Addendum No. 4

Invitation to Tender ES-21-01 Construction Services for Cummings Road Regional Transfer Station Redevelopment

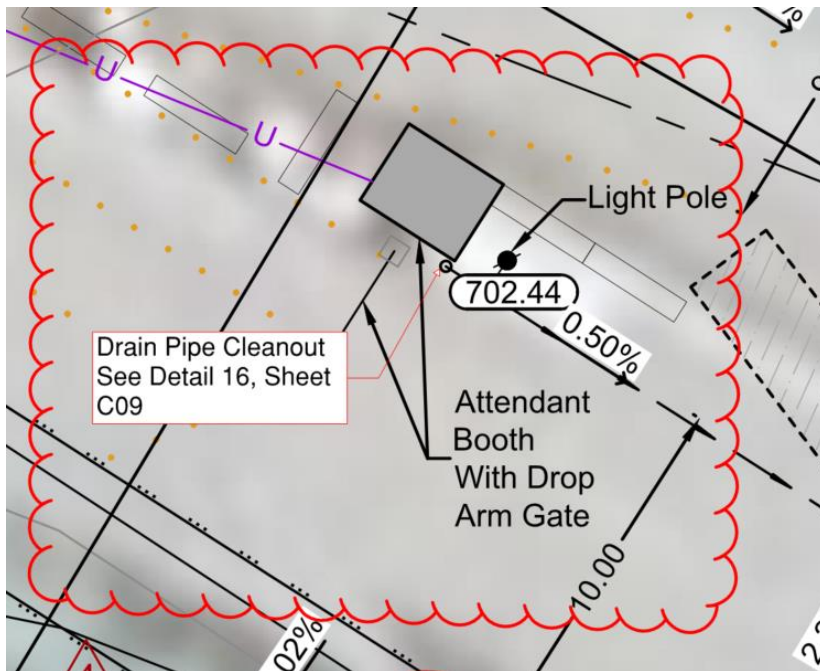
Question: French Drain: The detail shows that there is no top to the French drain (just drain rock to the top) Is the drain rock to be exposed to surface traffic?

Answer: Yes. Contractor shall provide an additional 150 mm drainpipe cleanout at the upstream end of the French drain. Refer to sketch below and detail 16, Sheet C09.
